ZTE CORPORATION

Product Change Description

[ZTE N9500]
[ZTE Corporation]
[Project Number:12ZTE132]
FCC ID: Q78-ZTEN9500

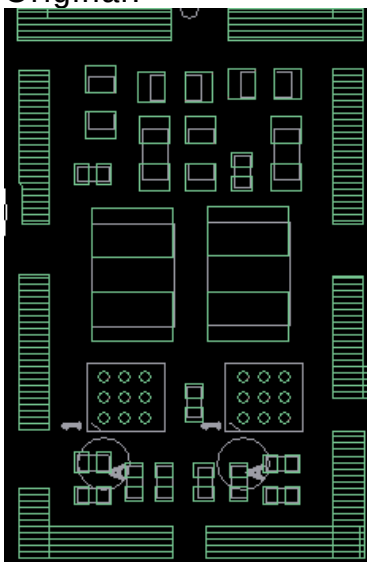
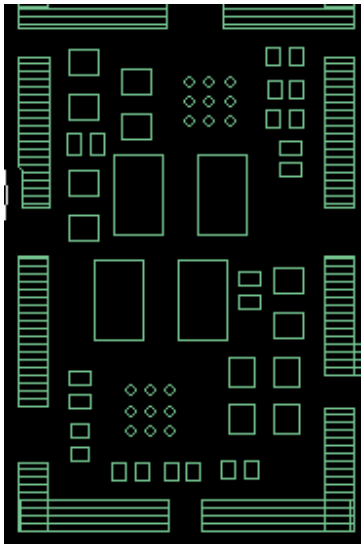
D: Optimize ADP components layout.
Please notice that only change components layout but PCB layout is same.
